STAGE 2 ROAD SAFETY AUDIT

Proposed Off-Site Highway Works
Warren Crest Farm, Wick Hill, Finchampstead, Wokingham

Report Title	Stage 2 Road Safety Audit
Prepared on behalf of	Wokingham Borough Council

RSA Report Ref	Issue No.	Date of Issue
002_8250668_GT	Issue 1 to Design Organisation, Alex Moeller (Glanville)	12 Mar 2026

*Approx. position of Sign Ref. B
(potentially within existing vegetation).*

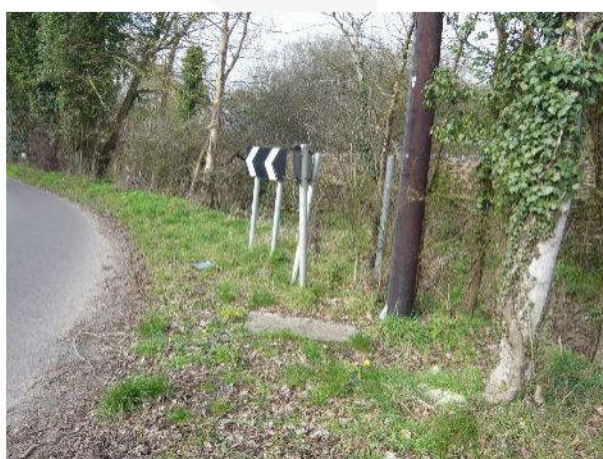
Location: Jubilee Road, west of proposed site.

Summary: Risk of obscured signage leading to possible loss of control and personal injury.

It is unclear where proposed Sign Ref. B will be positioned, noting that the existing footway at the location indicated on the drawings has a minimal width and the sloping verge beyond also contains other vegetation including boundary planting. There is a concern that in order to preserve the existing footway width and to achieve a minimum horizontal clearance between the kerb face and its leading edge, the sign assembly will need to be positioned well back from the carriageway. The sign plate may be obstructed by vegetation and this may result in vehicles failing to slow sufficiently leading to loss of control and secondary collisions with possible personal occurring.

It is recommended that proposed Sign Ref. B should be positioned such that the horizontal clearance is not less than the recommended minimum, the existing footway width is preserved and the sign plate is not obscured by existing vegetation.

Figure 1

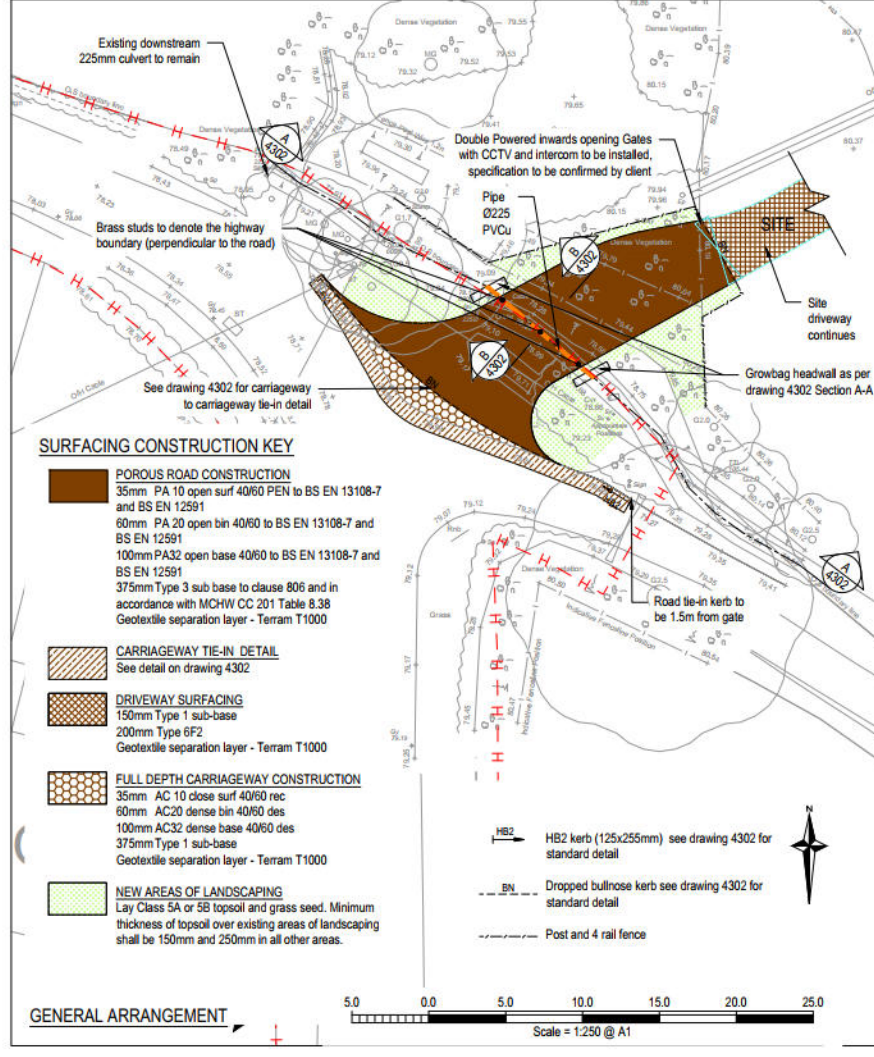
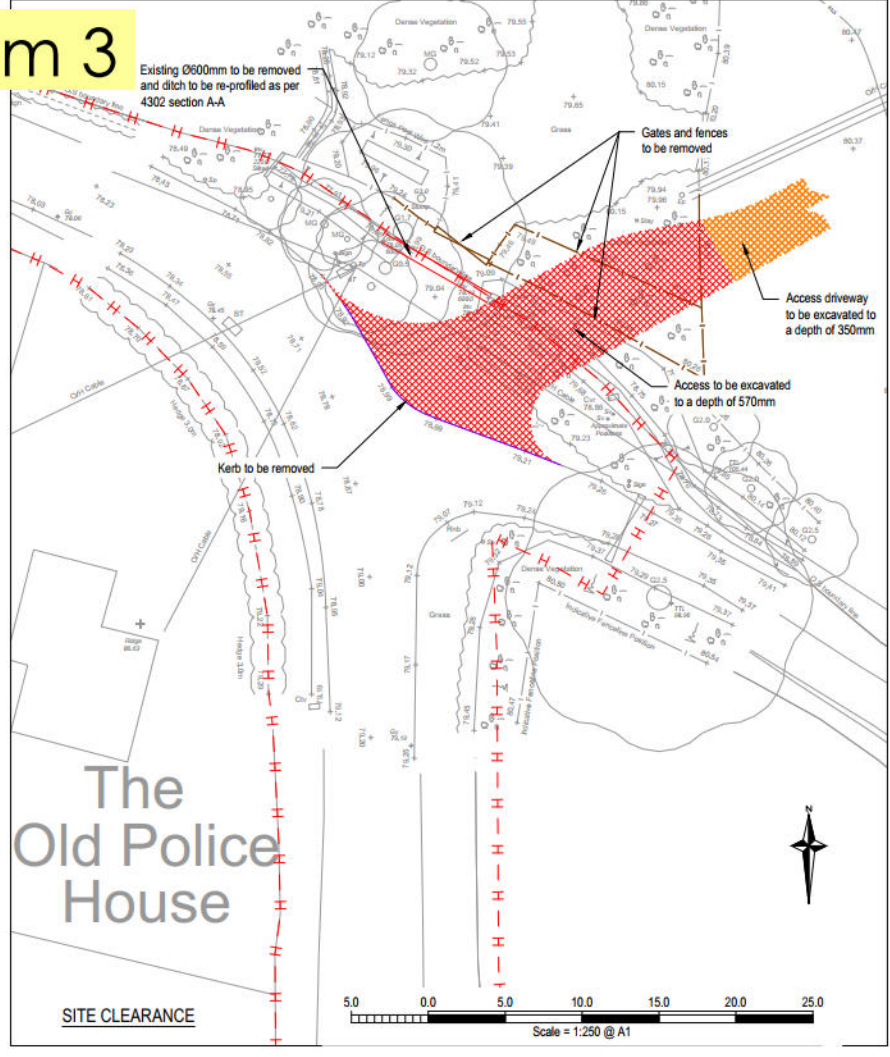
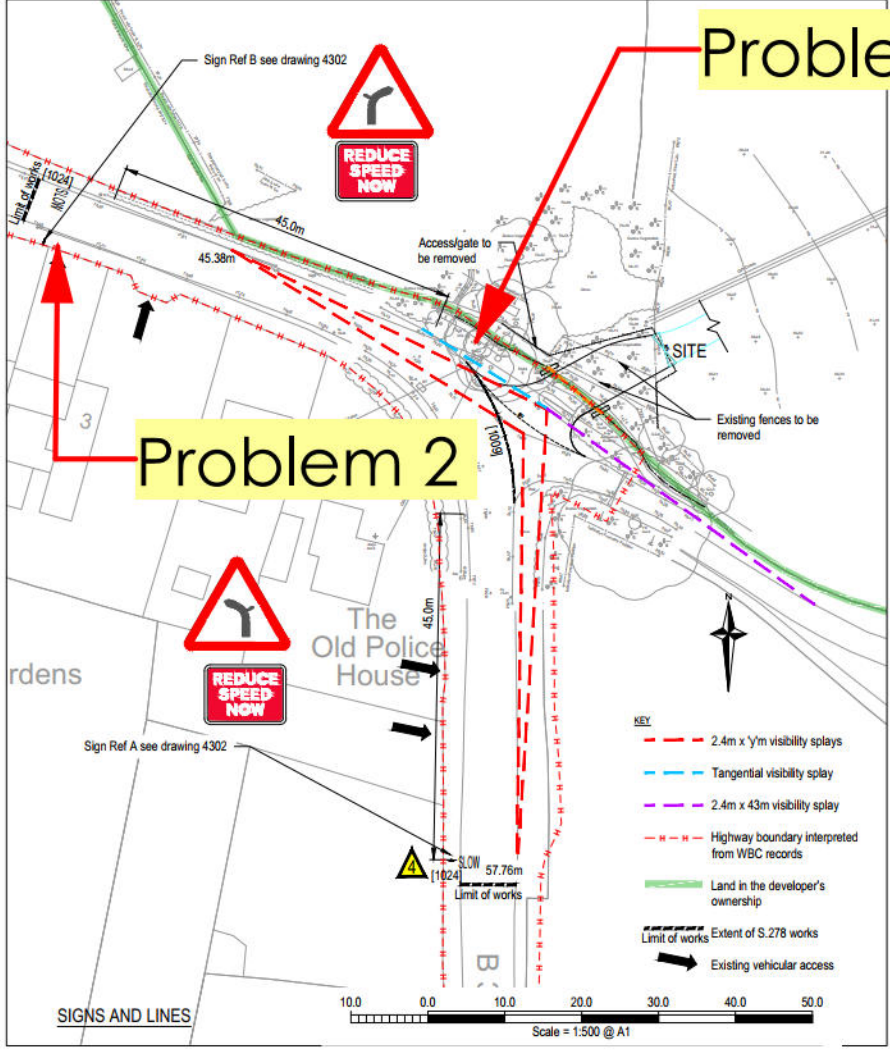
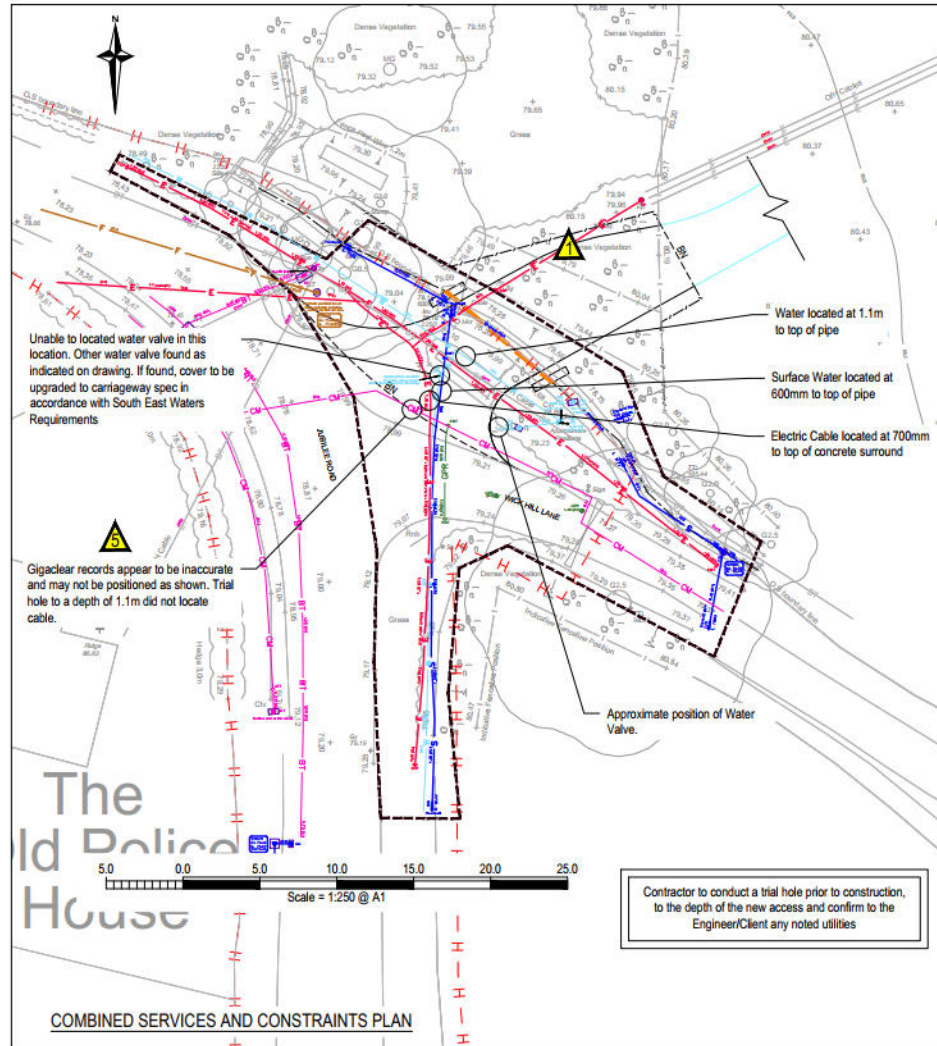
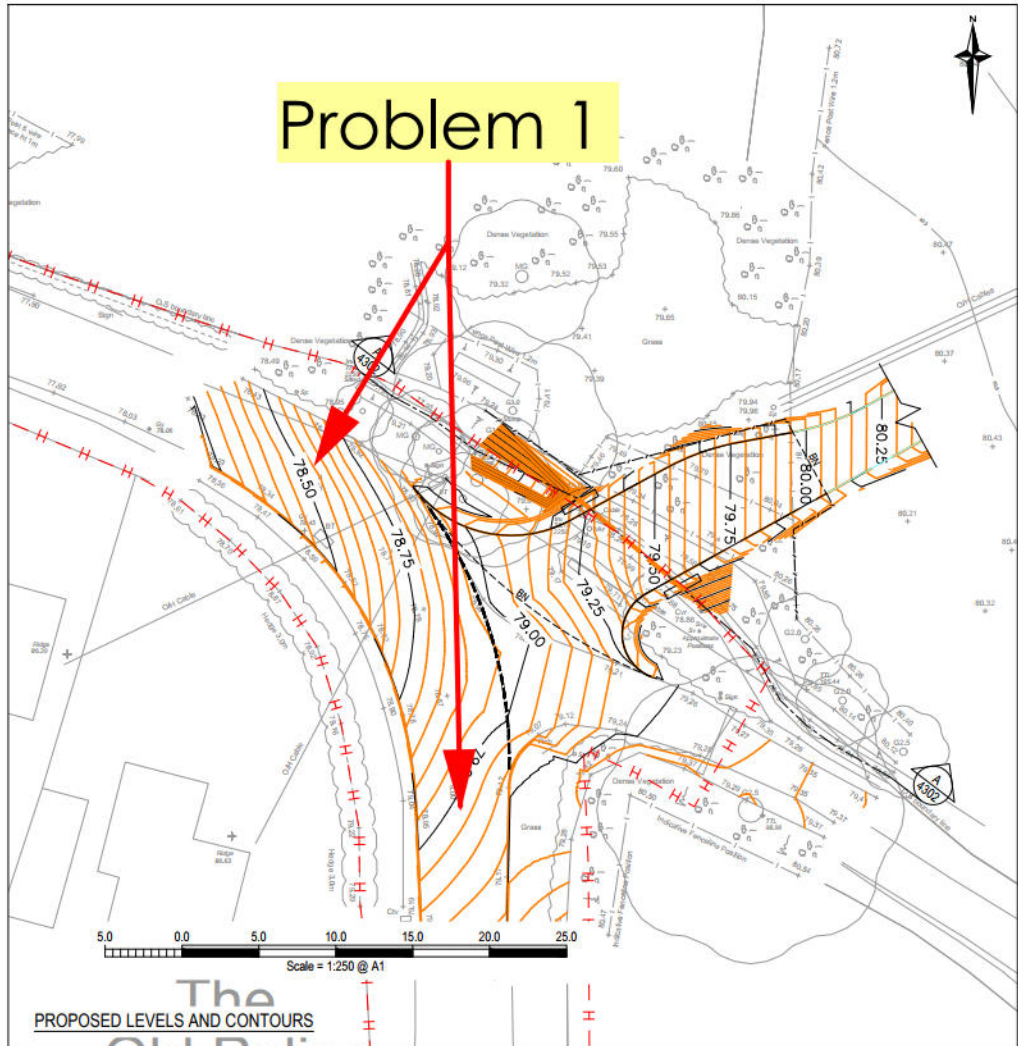
- 1.14 All road safety related problems and recommendations detailed in Section 3.0 are referenced to the layout drawing at Figure 1.
